MPC STAFF REPORT

Subdivision/Final Plat

West 40th Division

MPC File No. 25-004955-SUBP

Proposed subdivision - West 40th Division

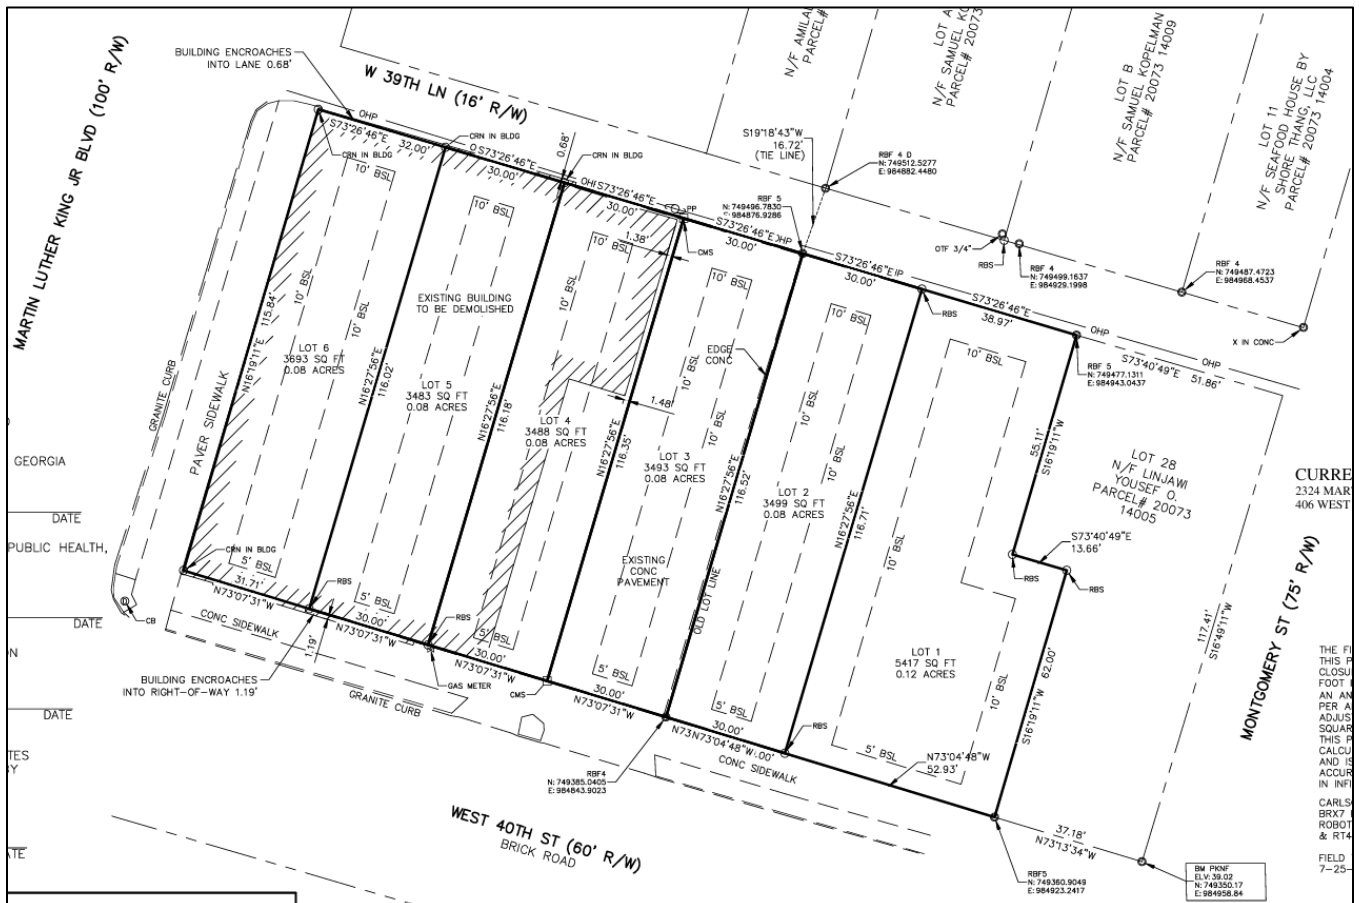
The proposed subdivision is generally consistent with the requirements of the City of Savannah Subdivision Regulations and Zoning Ordinance. All proposed lots meet the minimum lot area and lot width requirements of the TC-2 zoning district and front a publicly dedicated street. Building

setback lines are shown on the final plat, and the subdivision will be served by public water, sewer, and stormwater utilities. The proposal is located within the Streetcar Historic District; however, because the existing structure is non-contributing, a Certificate of Appropriateness is not required. Staff finds the proposed subdivision meets the applicable subdivision standards, subject to the recommended conditions regarding demolition, parking compliance, and submission of an Environmental Site Assessment prior to final plat approval.

MPC Staff recommends **approval** of the proposed subdivision with the following conditions;

1. The demolition permit 26-05682-BC must be issued prior to the final approval of this subdivision.
2. Provide zoning confirmation that off-street parking requirement will be met prior to the final approval of this subdivision.
3. Provide Environmental Site Assessment for the site prior to the final approval of this subdivision.
